## Supplemental Instruction

**The Park Danforth**

13-059-00

**DRAWING CLARIFICATIONS FROM AHJ REVIEW**

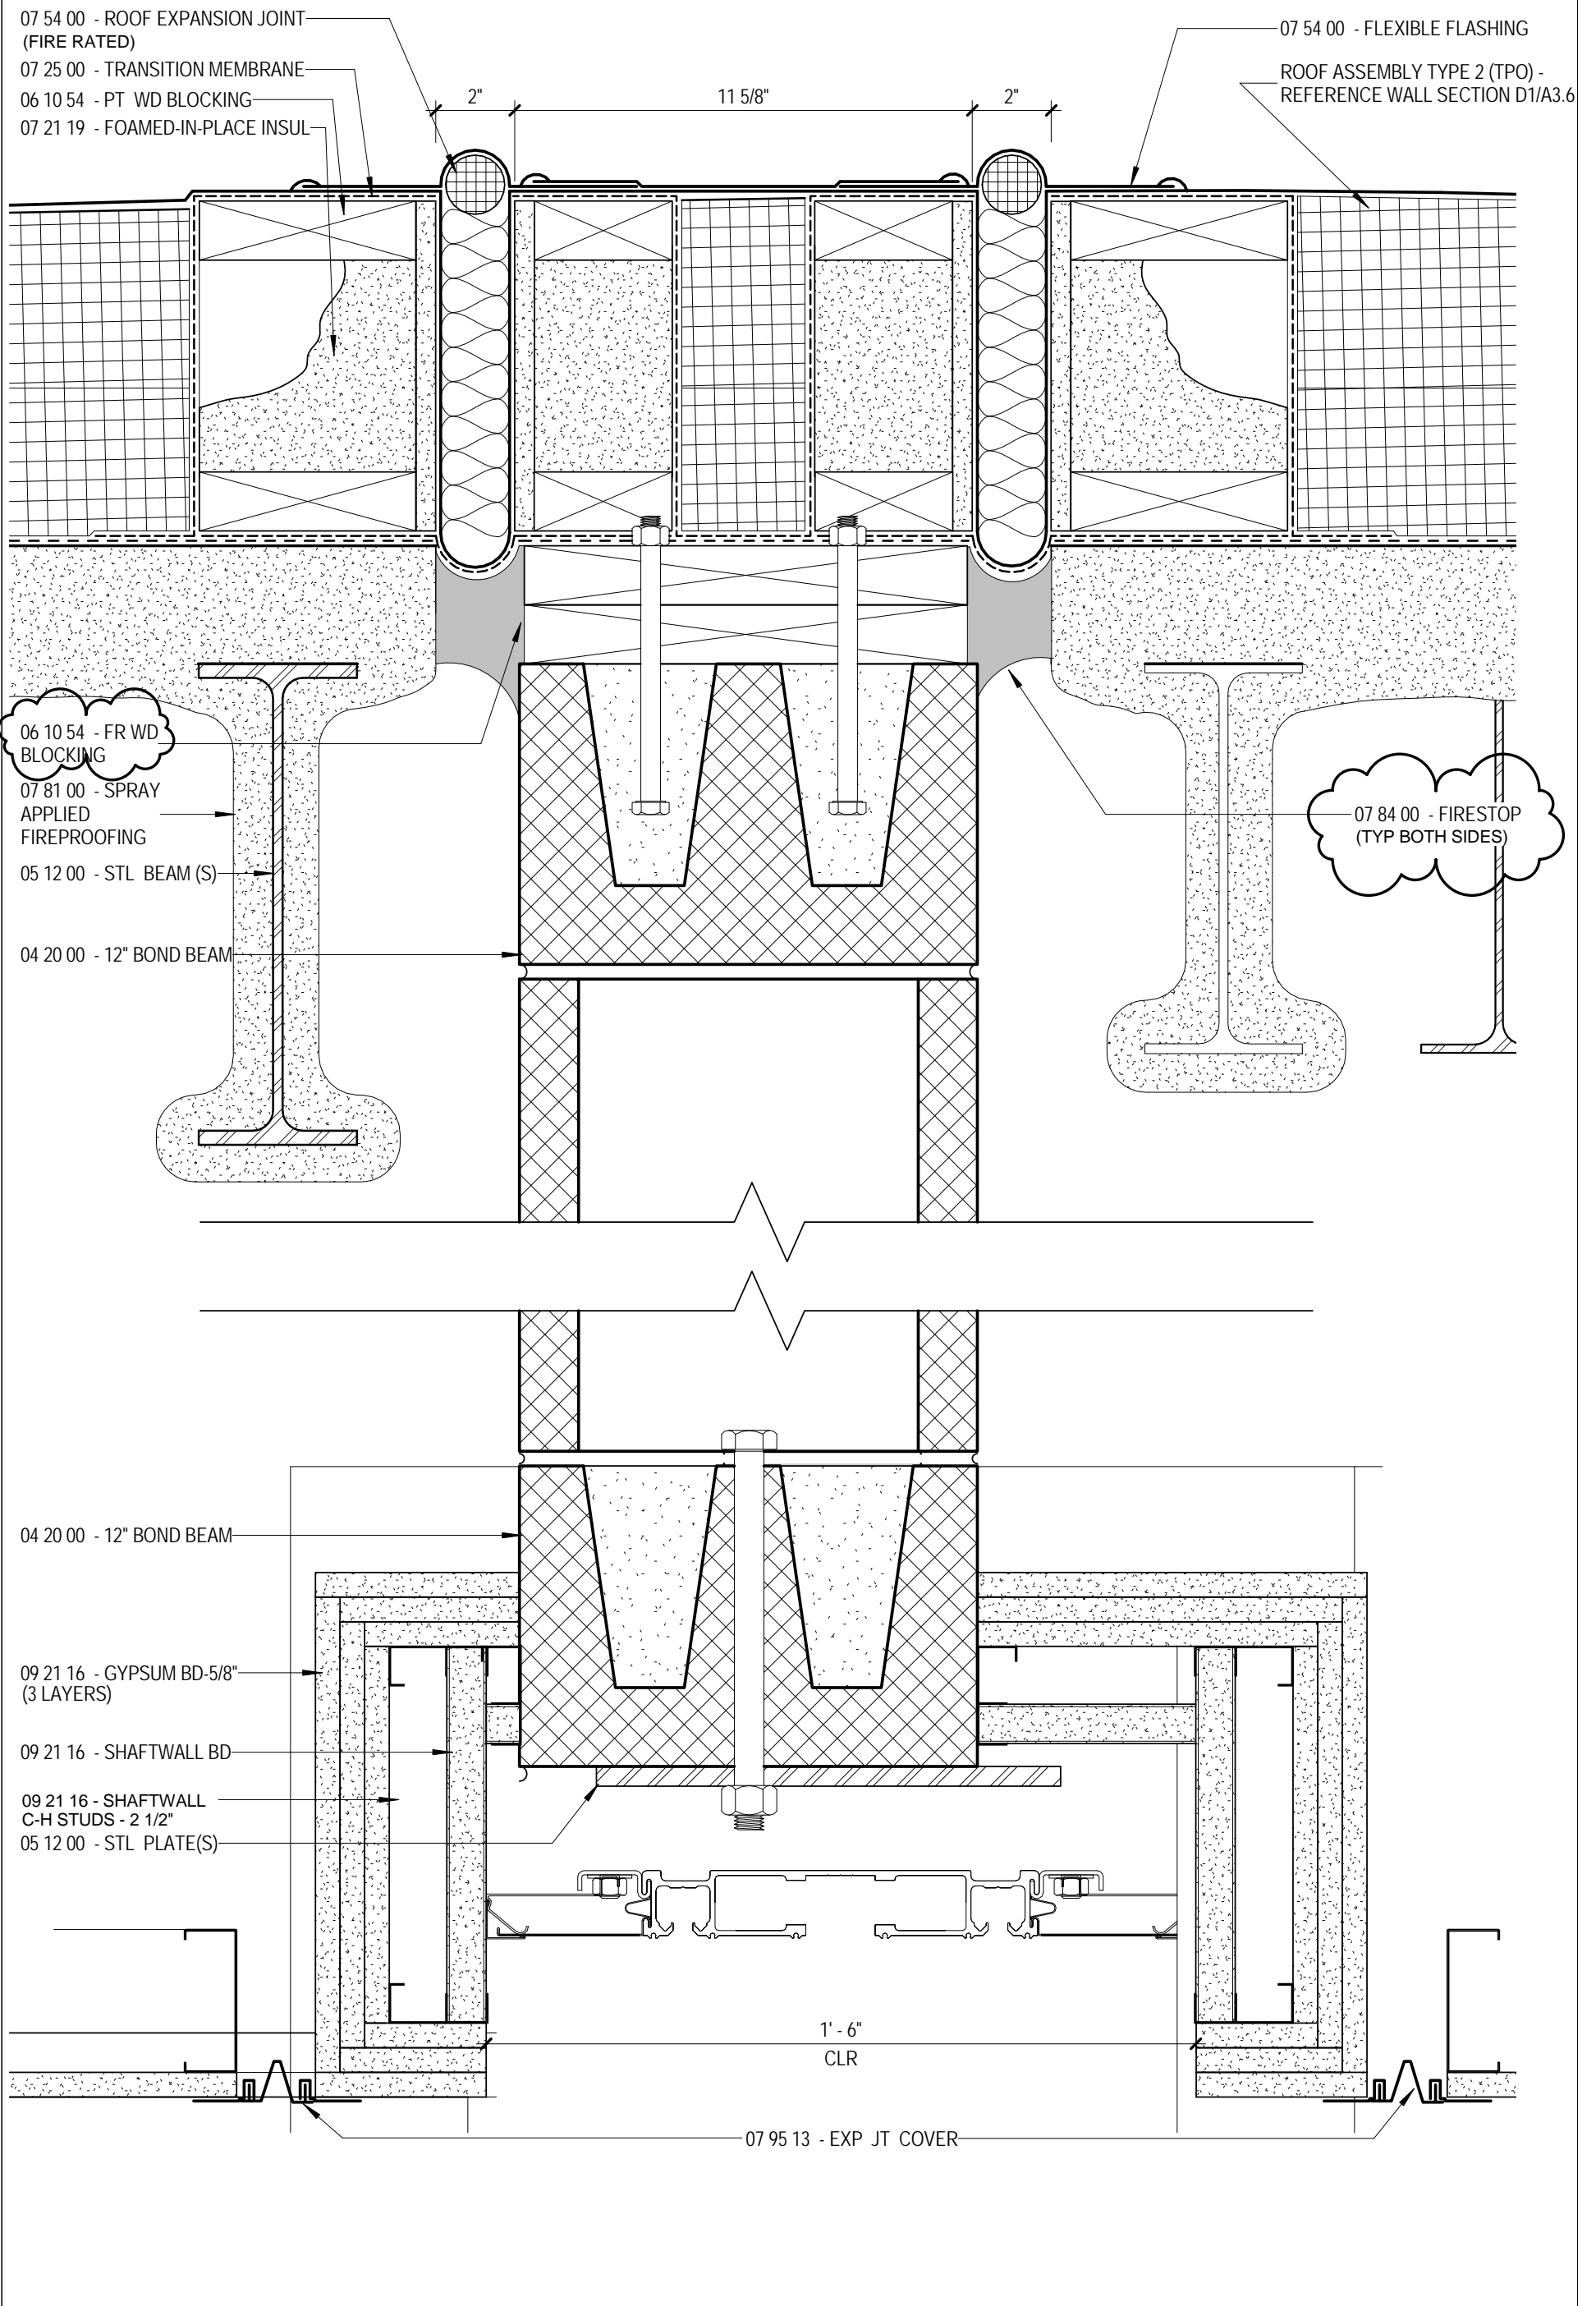
1. Reference Wall Section D7/A3.6: Delete the following: "REFERENCE WALL SECTION D12/A3.6", from the Roof Assembly Type 3 note.
2. Reference Section E6/A3.16 - Section Detail @ Firewall: See attached sketch for clarifications.
